November 1, 2023

To: City of Madison Landmarks Commission

Re: Old Spring Tavern property and proposed house at 3701 Council Crest
Legistar File ID No. 79099

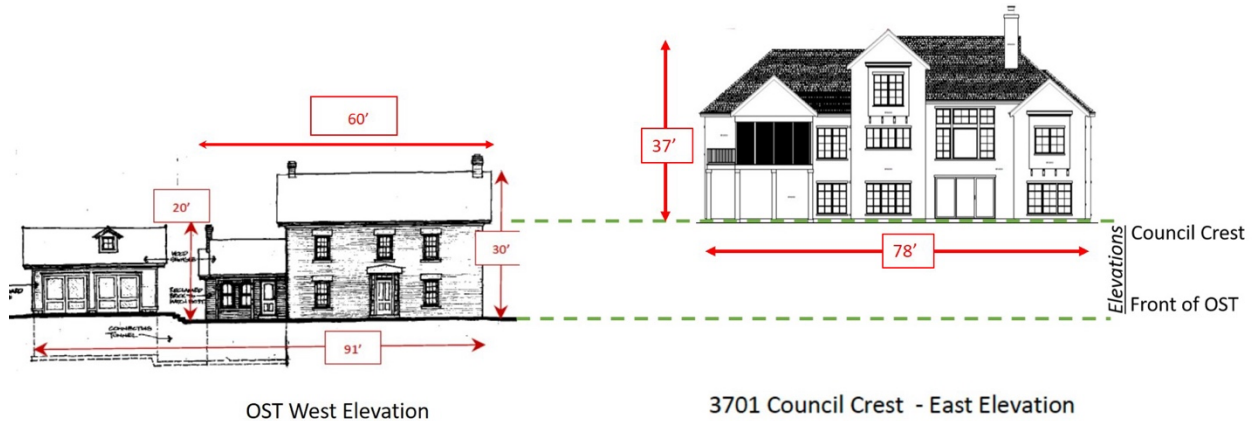
Standard 9. The new work shall be compatible in its massing, size, scale and architectural features to protect the historic integrity of the property. The proposed new house is significantly larger in square footage and mass than the historic Tavern. It is much taller and wider, and its bulk and height are accentuated by the fact that it is situated on a slope with its base ten feet above the base of the Tavern. From the front door and front windows of the Tavern, people would be looking at a three-story building with its base one story above the Tavern’s base, meaning its roofline would be four stories above the base of the front door.

The drawings below show how the proposed house is much taller than the Tavern, with its roofline 17 feet higher than the roof of the Tavern. It is much wider than the Tavern, and it is located only 26 yards from the front door of the Tavern. It is very rare to have another house located so close to the front door of an existing house. All of this makes it completely incompatible with the historic nature of the property.

A substantially smaller, less massive, narrower and shorter house, with its back wall farther from the front door of the Tavern, would not visually overwhelm the historic Tavern and would leave much more of the west yard with its historic open appearance. However, the proposed very large house is not compatible with or respectful of the historic Tavern and the historic west yard.
